BAKERSFIELD (ITY SCHOOL DISTRICT RELOCATION OF (9) MODULAR (LASSROOMS AND (1) MODULAR RESTROOM AT ERANKLIN ELEMENTARY SCHOOL BAKERSFIELD, KERN (OUNTY, (ALIFORNIA)

BID OPENING: May 22nd, 2025 at 2:00pm, Job No. 1348 Appl. No. 15-6 File No. 03-123703

ADDENDUM NO. #02

B) PARTIAL DEMO SITE PLAN

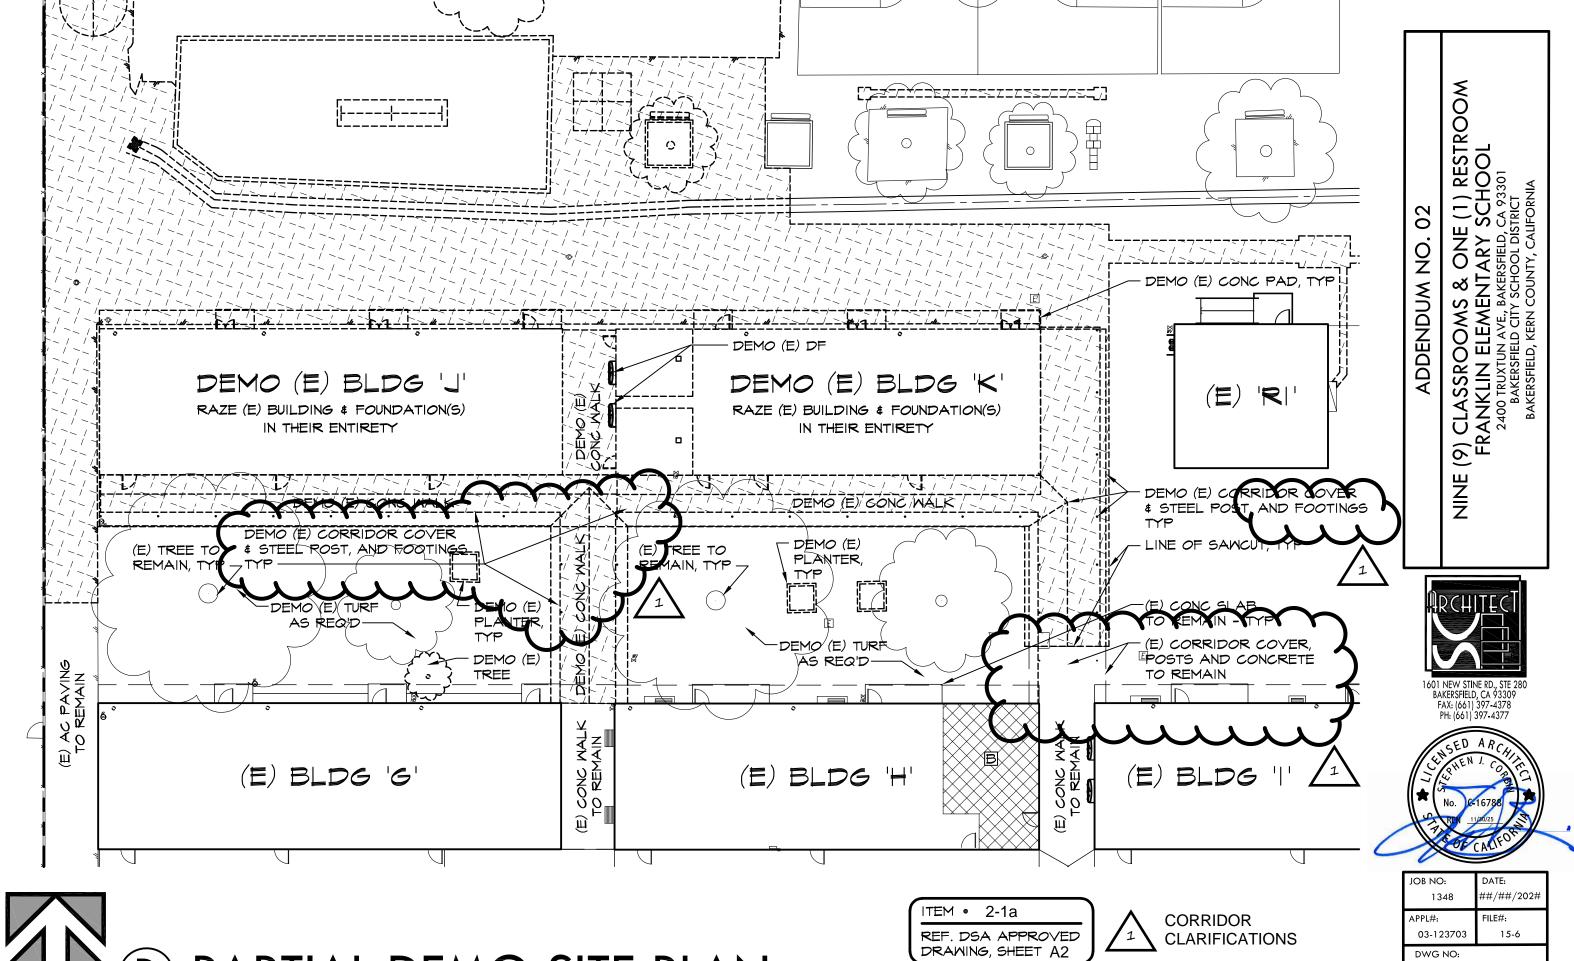
- 2-1) Refer to DSA Approved Project Drawings, Sheet No. A2 PARTIAL SITE PLAN, B PARTIAL DEMO SITE PLAN;
 - REVISE: Portion of (E) corridor cover and concrete walk at the North side of Buildings "H" and "I" shall be existing to remain in lieu of demolition as indicated per attached Drawing No. 01.

- b. CLARIFY: (E) corridor cover, posts and footings on South side of Buildings "J" and "K" shall be demolished as indicated per attached Drawing No. 01.

- c. ADD: Demolition of footings for (E) steel posts at corridor cover as indicated per attached Drawing No. 01.
- 2-2) Refer to DSA Approved Project Drawings, Sheet No. A2 PARTIAL SITE PLAN, (A) PARTIAL SITE PLAN;

PARTIAL SITE PLAN

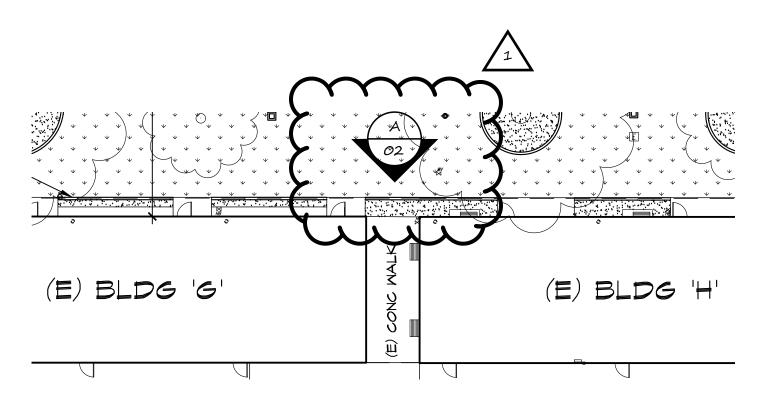
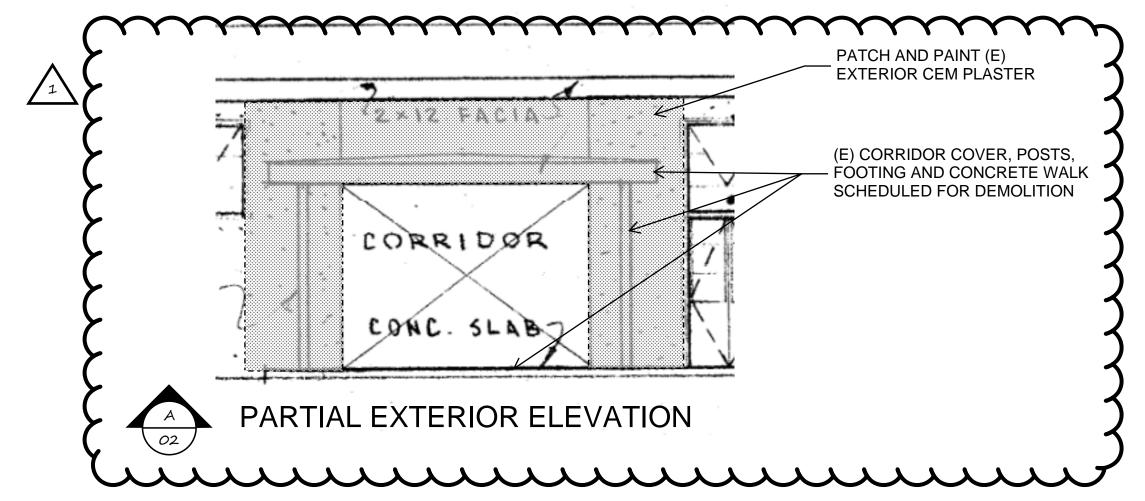
- a. ADD: Patching and painting of (E) exterior cement plaster as indicated per attached Drawing No. 02.
- 2-3) Refer to DSA Approved Specifications, INDEX, DIVISION 09 FINISHES;

ADD PATCHING AND PAINTING OF (E) **EXTERIOR CEM PLASTER**
